Re: Addendum #1
Town of Ridgeland
Effluent Filter and Pump Hoists Project

EFFLUENT FILTER AND PUMP HOISTS

JIMMY MIXSON WATER RECLAMATION FACILITY

RELEASE	DATE	SHEETS INCLUDED	SHEETS REVISED	DESCRIPTION
A	2/12/26	Sheets 1-8	Sheets 1-8	Issued for Bidding
B	4/6/26	Sheets 1-8	Sheets 1, 3	Addendum #1

SHEET TITLE
Influent Pump Hoist Plan and Section

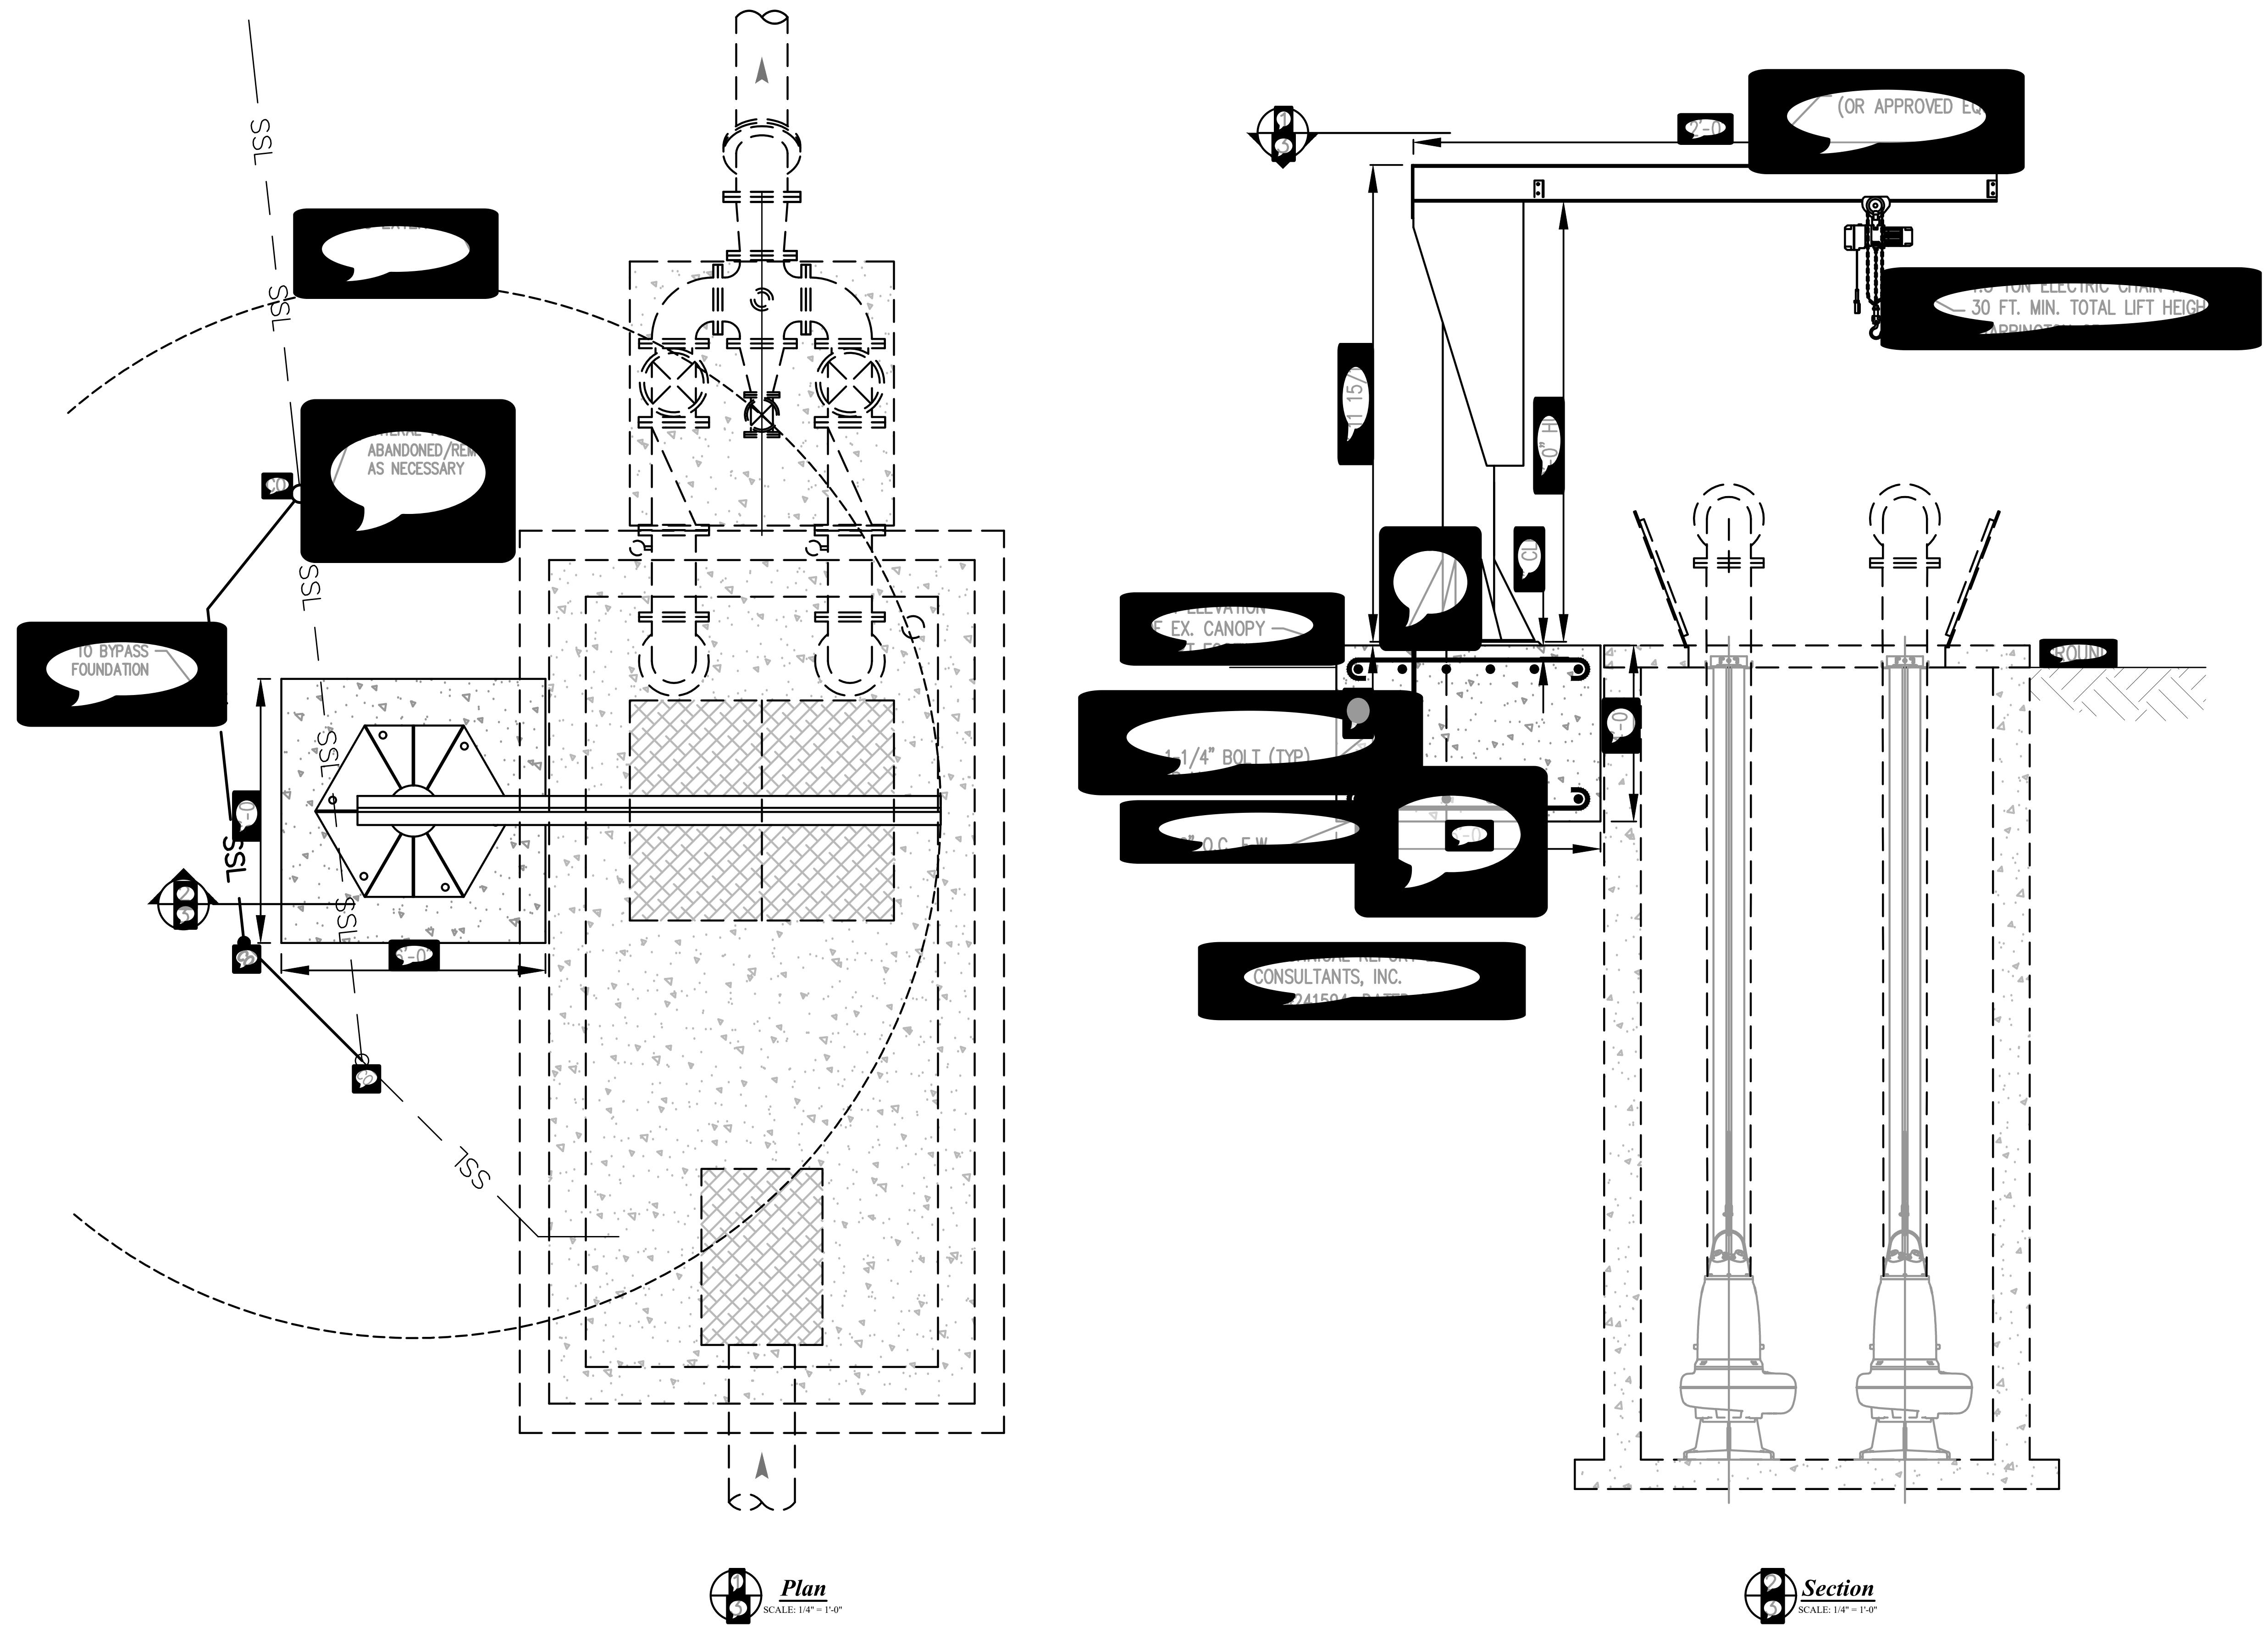
Addendum Reference #	Reference	Question / comment
1.0	Pre-Bid Sign In Sheet	Attached is the sign in sheet from the pre-bid meeting.
1.1	Plan Sheet 6	Q: What is the size, pipe material, and depth of the sanitary sewer line that needs to be rerouted around the influent jib crane base? A: It is a service lateral from the operations buildings. 6-inch PVC. The invert into the influent wetwell is approximately 5 feet below the top of the wetwell.

SHEET TITLE
Effluent Pump Hoist Plan and Section

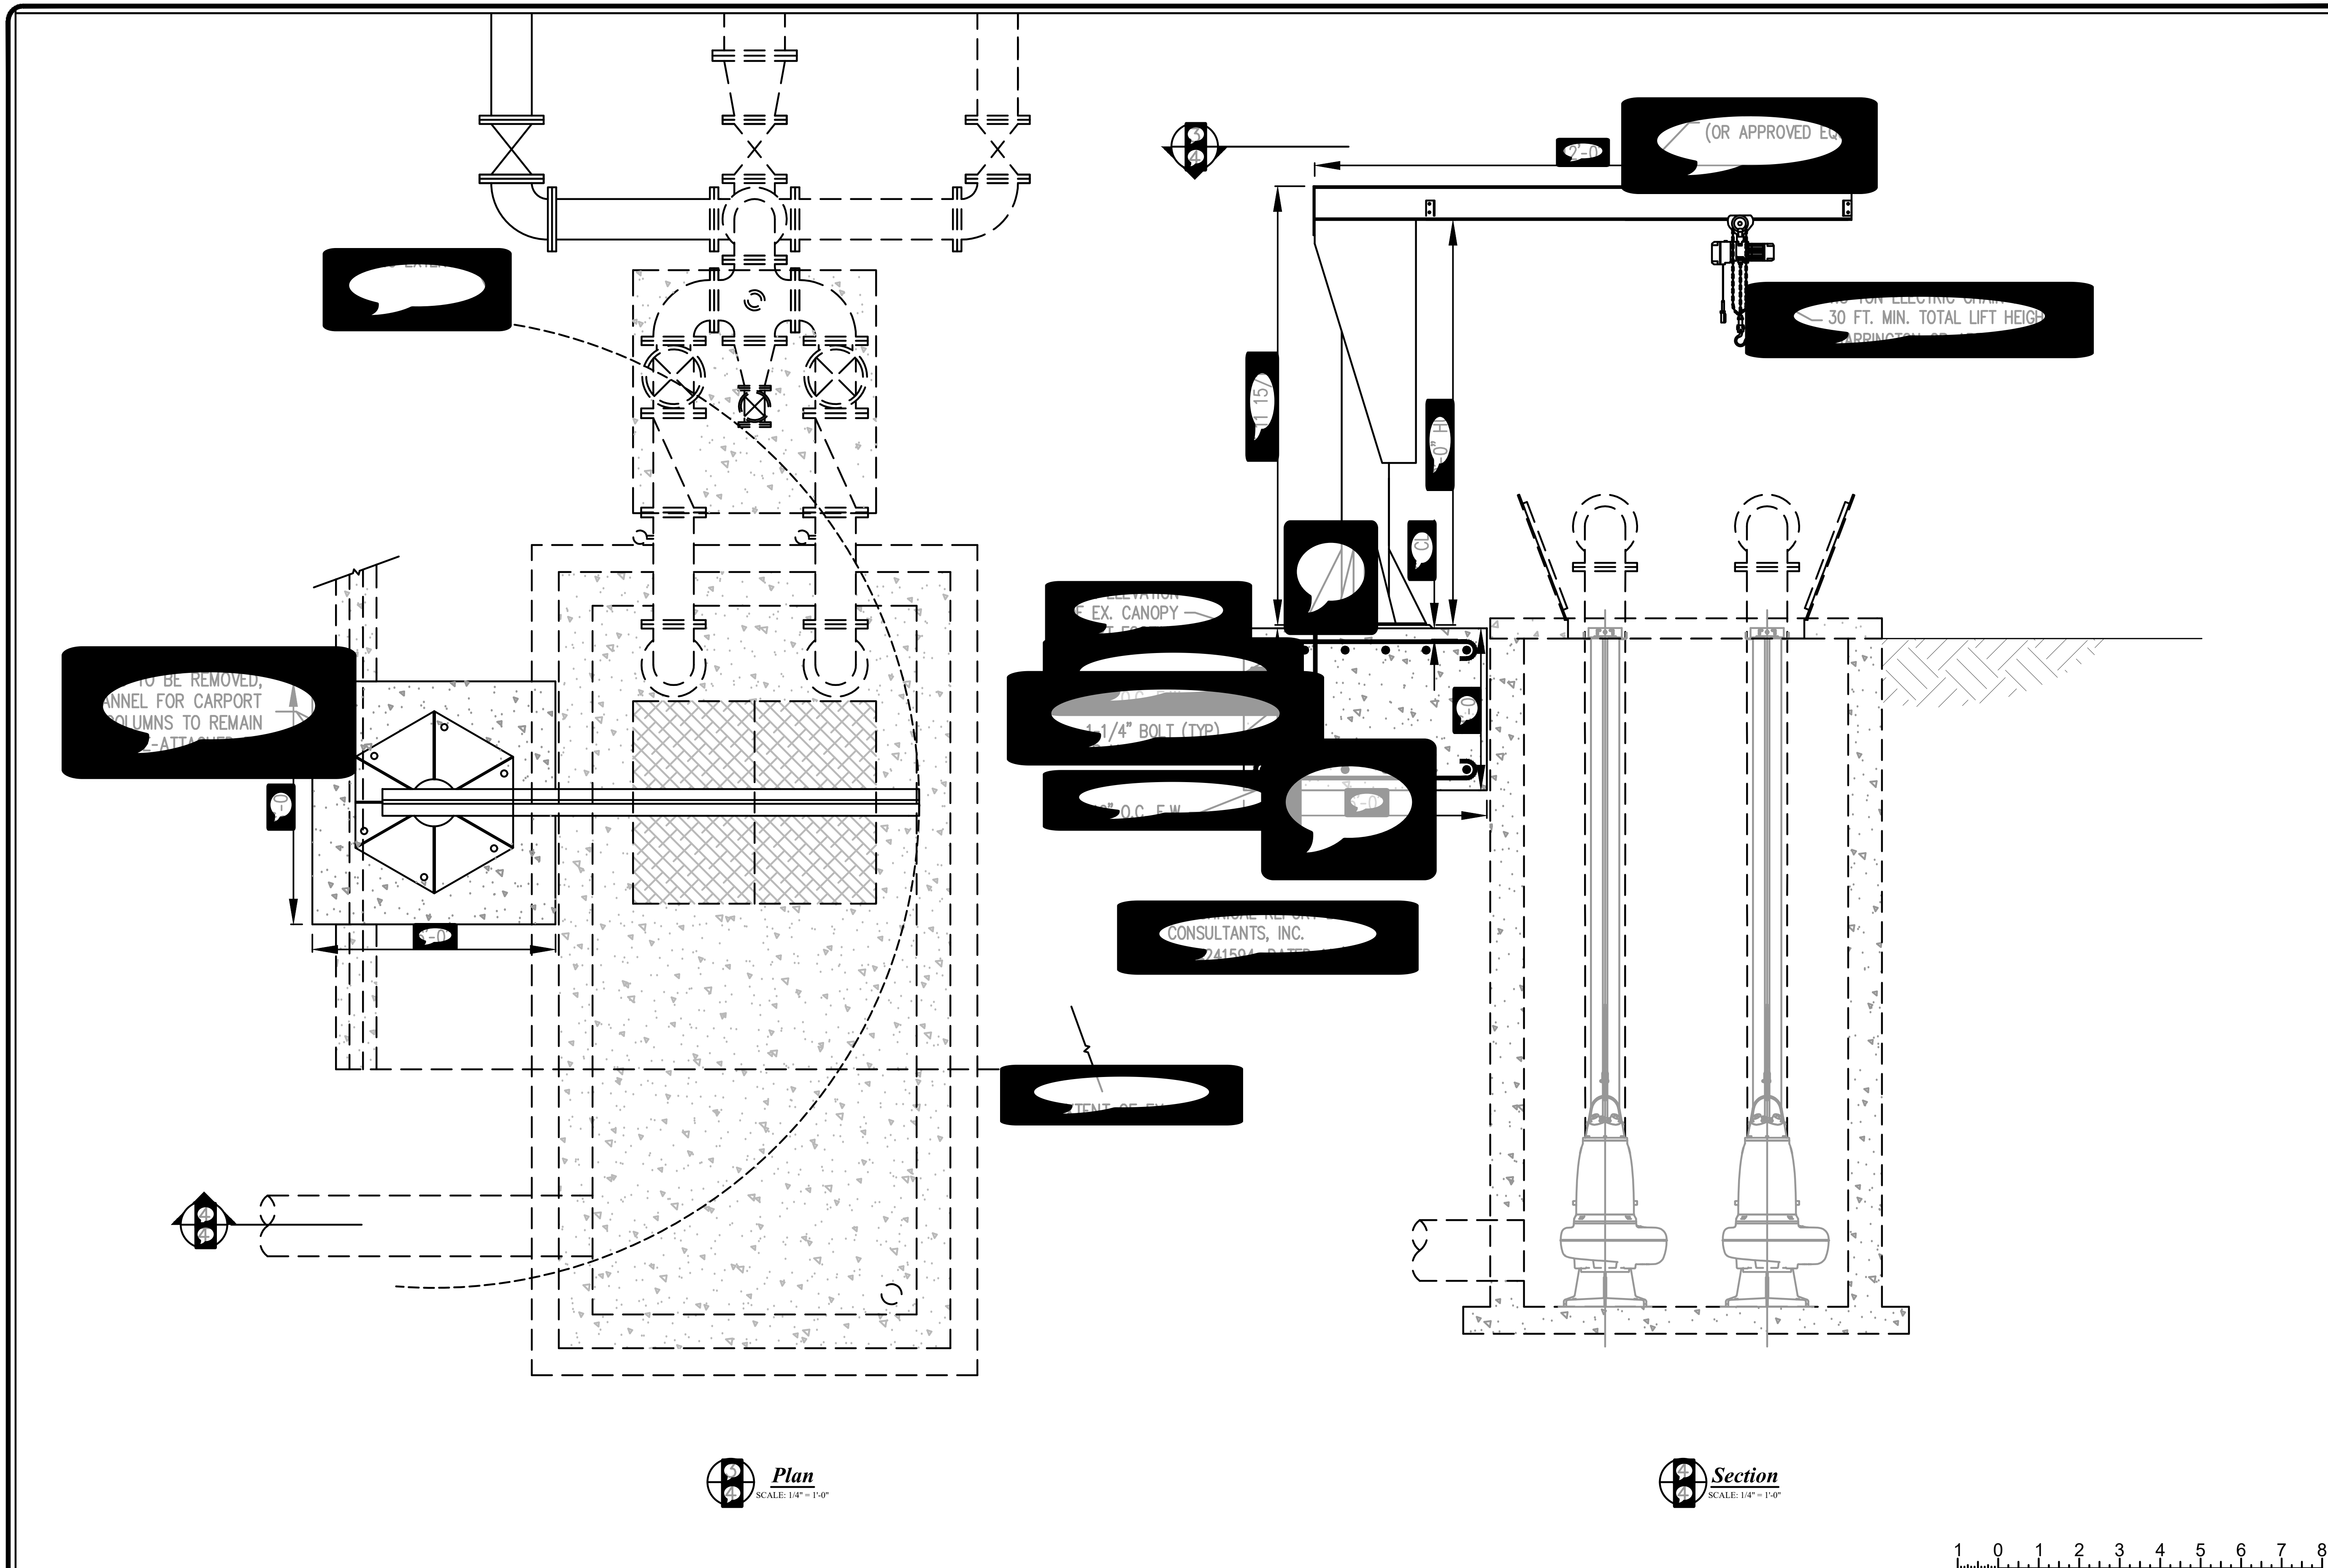
1.11	Section 41 22 13.19	Q: Please provide a specification for the jib cranes. A: See attached specification Section 41 22 13.19 – Jib Crane.
1.12	Plan Sheets 3 and 7	Q: Is it the intention to depict all existing piping with dashed lines and new piping with solid lines? If so, please clarify if the piping exiting the effluent pump station is existing as shown in page 3. Or new as shown in page 7. A: The intention is to depict all existing piping with dashed lines and proposed piping with solid lines. All effluent filter underground piping exists. See Effluent Filter existing conditions photo log.

1.13		Q: If the piping exiting the effluent pump station is new, please clarify whether it is to be configured as shown on page 3 by splitting off with a tee, or as shown on page 7, splitting off with a cross and additional valve. A: See Addundum item 1.12.

1.16	Plan Sheets 6 and 7 Section 03 30 00	Q: Please confirm that the concrete material for the jib crane bases is to be 3,000 psi per the notes in the drawings, and not 4,000 or 4,500 as described in the specs. A: Jib crane foundations are to be 3,000 psi concrete as shown on the plans. Section 03 30 00 provides 3,000 psi design mix.
